TRANSPORT ASSESSMENT

PROPOSED WAREHOUSE DEVELOPMENT

PROPOSED LOT 104 FLAGSTONE LOGISTICS ESTATE,
NORTH MACLEAN

(RESPONSE TO INFORMATION REQUEST DATED 5 NOVEMBER 2024)

FIGURE 6.9– VEHICLE SWEEP PATH (B – DOUBLE)

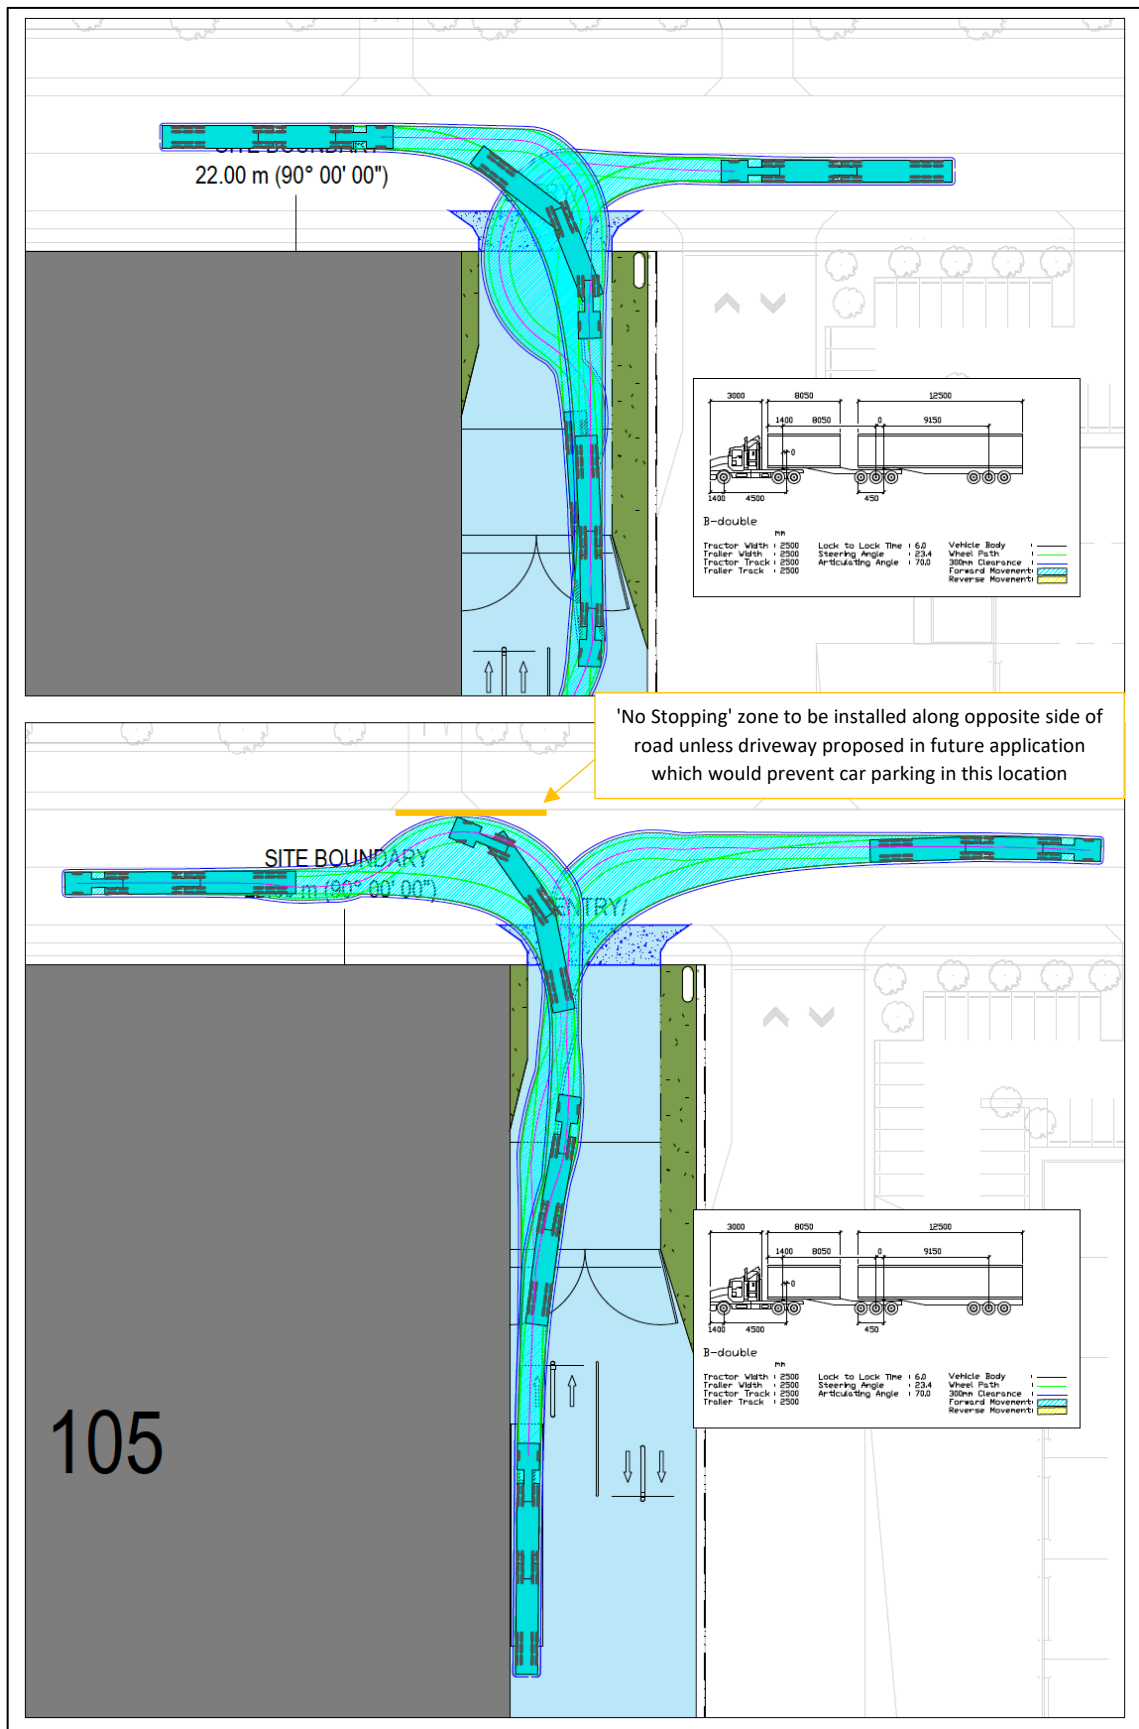
- e) A review of the vehicle swept path for B-doubles within Figure 6.9 of the submitted Transport Assessment report (prepared by Rytenskild, Version 1, dated 12 September 2024) indicates that the left exit may impact upon the street parking on the opposing lane. Therefore, the following further information is required to address this concern:**

- i) Submit amended swept path plans to indicate a yellow line marking on the street parking to prohibit vehicles from parking on that section of the street, or**

- ii) Submit amended swept path plans with variations to the B-double's left exit path to prevent it from impacting street parking.**

- i. As shown in Figure 6.9, a 'No Stopping' zone is proposed to be installed along the opposite side of the road to allow for satisfactory manoeuvring of B-Double vehicles.
- ii. As shown in Figure 6.9, the swept path for the B-Double has been adjusted to minimise its impact on the car parking located on the opposite side of the road.

As shown in Figure 6.9, a 'No Stopping' zone is proposed to be installed along the opposite side of the road to allow for satisfactory manoeuvring of B-Double vehicles.
